Attachment A
Section 92 Response,
parts 1, 2, 3

Te Tupu Ngātahi
Supporting Growth
PO Box 105218
Auckland 1143

Attachment A: Section 92 response

Table 1: Proposed Flood Hazard Condition – changes since lodgement and rationale

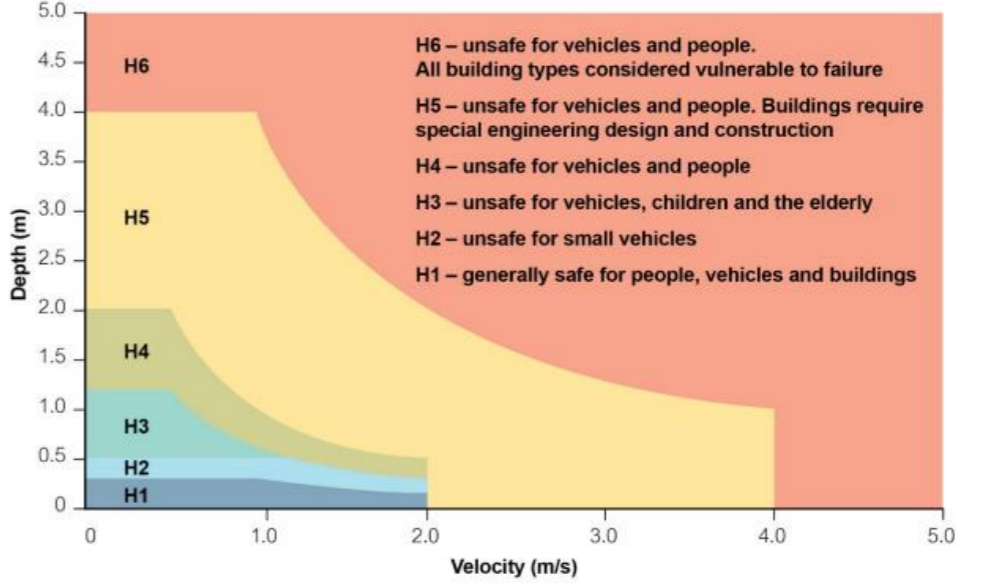
The table below sets out the Flood Hazard condition proposed at lodgment, the changes proposed as a result of a review of the condition carried out in December 2023 and our reasons for those changes.

Condition as lodged Sept 2023 (Appendix B, condition 10)	Proposed change to condition	Rationale for change from conditions as lodged
(a) The Project shall be designed to achieve the following flood risk outcomes:	The Project shall be designed to achieve the following flood risk outcomes:	N/A
<ul style="list-style-type: none"> i. no increase in flood levels in a 1% AEP event for existing authorised habitable floors that are already subject to flooding or have a freeboard less than 150mm; 	<ul style="list-style-type: none"> no increase in flood levels in a 1% AEP event for existing authorised habitable floors that are already subject to flooding or have a freeboard less than 150mm500mm; 	<p>A site assessment was carried out to estimate the amount of freeboard at buildings that might be affected by flooding close to the proposed NoR boundary (refer Section 4 and the maps in Appendix 1 of the Supplementary Flood Hazard Assessment). When the freeboard was estimated, the majority of those existing floors assessed were either flooded or within 150mm of flooding. Changing to 500mm had a minor increase in the number of floors subject to this condition but the controlling criteria was typically the building with freeboard less than 150mm.</p> <p>The new criteria also provides better protection for relatively new buildings that may be constructed prior to lodgement of the OPW– which is relevant to NoRs near flooding within the Future Urban Zone.</p> <p>Increasing freeboard to 500mm for these types of buildings aligns with freeboard standards in the AC Stormwater Code of Practice for new builds.</p> <p>It is not intended to protect all future buildings – those constructed after the OPW are lodged are expected to set appropriate freeboard above the Post project flood level.</p>

<ul style="list-style-type: none"> ii. no more than a 10% reduction in freeboard in a 1% AEP event for existing authorised habitable floors with a freeboard over 150mm; 	<ul style="list-style-type: none"> no more than a 10% reduction in freeboard in a 1% AEP event for existing authorised habitable floors to maintain a minimum with a freeboard of over 150mm; 	<p>A percentage freeboard reduction is not needed if a freeboard of 500mm is utilised in criteria i.</p>

Condition as lodged Sept 2023 (Appendix B, condition 10)	Proposed change to condition	Rationale for change from conditions as lodged
<p>iii. no increase in 1% AEP flood levels for existing authorised community, commercial and industrial building floors that are already subject to flooding;</p>	<p>no increase in 1% AEP flood levels for existing authorised community, commercial, industrial and network utility building floors that are already subject to flooding or have a freeboard of less than 300mm;</p>	<p>This criterion has been introduced to address flood effects as these types of building are present in the Project area – such as east of SH1 (NoR4).</p> <p>Increasing the freeboard to 300mm for these types of buildings aligns with freeboard standards in the AC Stormwater Code of Practice for new builds.</p> <p>Given the potential town centre areas in the Future Urban Zone there is potential for more of them to be constructed prior to the lodgement of the OPW. The new criteria provides better protection for relatively new buildings.</p>

<p>vi. no new flood prone areas;</p>	<p>no new flood prone areas; and</p>	<p>No change.</p>
<p>vii. no more than a 10% average increase of flood hazard (defined as flow depth times velocity) for main access to authorised habitable dwellings existing at time the Outline Plan is submitted. The assessment shall be undertaken for the 1% AEP rainfall event.</p>	<p>No increase of flood hazard for main vehicle access to authorised habitable dwellings existing at time the Outline Plan is submitted. The assessment shall be undertaken for the 1% AEP rainfall event. Where Flood Hazard is:</p> <ul style="list-style-type: none"> • Velocity x depth >= 0.6 or • depth > 0.5m, or • velocity >2m/s. <p>no more than a 10% average increase of flood hazard (defined as flow depth times velocity) for main access to authorised habitable dwellings existing at time the Outline Plan is submitted. The assessment shall be undertaken for the 1% AEP rainfall event.</p>	<p>The wording has been changed to reflect the change from category H2 to H3 in the Australian Institute of Disaster Resilience 2017, Handbook 7, Managing the Floodplain. Using categories of protection, allows some changes to depth or velocity within category 2 while providing appropriate protection.</p> <p>The protection of both pedestrians and small vehicles are covered within category H2.</p>
